# UNITED STATES PATENT AND TRADEMARK OFFICE

## Office Action Summary

10/756,775

## **DETAILED ACTION**

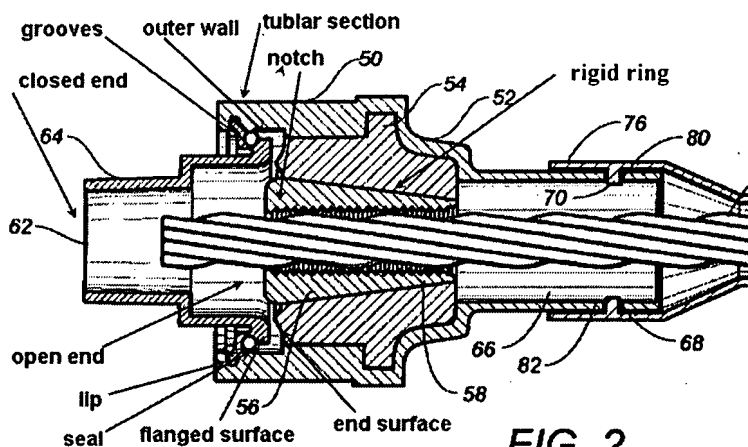
7. In Re claim 10, Figure 2 (See modified Figure 2 above) of Sorkin discloses a tubular body having an open end and a closed end; and a flanged surface extending radially outwardly of said tubular body at said open end, said flanged surface having an end surface and an outer wall extending outwardly therefrom, said outer wall having a lip formed at an end of said outer wall opposite said end surface, said lip projecting radially outwardly from said outer wall.

10. In Re claim 14, Figure 2 (See modified Figure 2 above) of Sorkin discloses an anchor member (54) having an end surface; a polymeric encapsulation covering (Column 4 Lines 1-17) said anchor member (54), said polymeric encapsulation having a tubular section extending outwardly of said end surface; a rigid ring affixed within said tubular section, said rigid ring having a notch formed on an inner wall thereof.

12. In Re claim 17, modified Figure 2 of Sorkin discloses a notch comprising a first notch formed around said inner wall of said rigid ring adjacent an end of rigid ring opposite said end surface of said anchor member.

13. In Re claim 18, modified Figure 2 of Sorkin discloses a notch further comprising a second notch formed around said inner wall of said rigid ring adjacent an opposite end of said rigid ring, said second notch being in spaced parallel relationship to said first notch. Examiner is considering the second notch to be one of the many other indentions on what has been labeled the rigid ring in the figure above.

14. In Re claim 19, modified Figure 2 of Sorkin discloses a rigid ring having a tapered surface at an end thereof adjacent an end of said tubular section of said polymeric encapsulation opposite said end surface of said anchor member.

15. In Re claim 20, modified Figure 2 of Sorkin discloses a tendon (74) affixed to said anchor member (54), said tendon (74) having an end extending outwardly of said end surface of said anchor member (54).
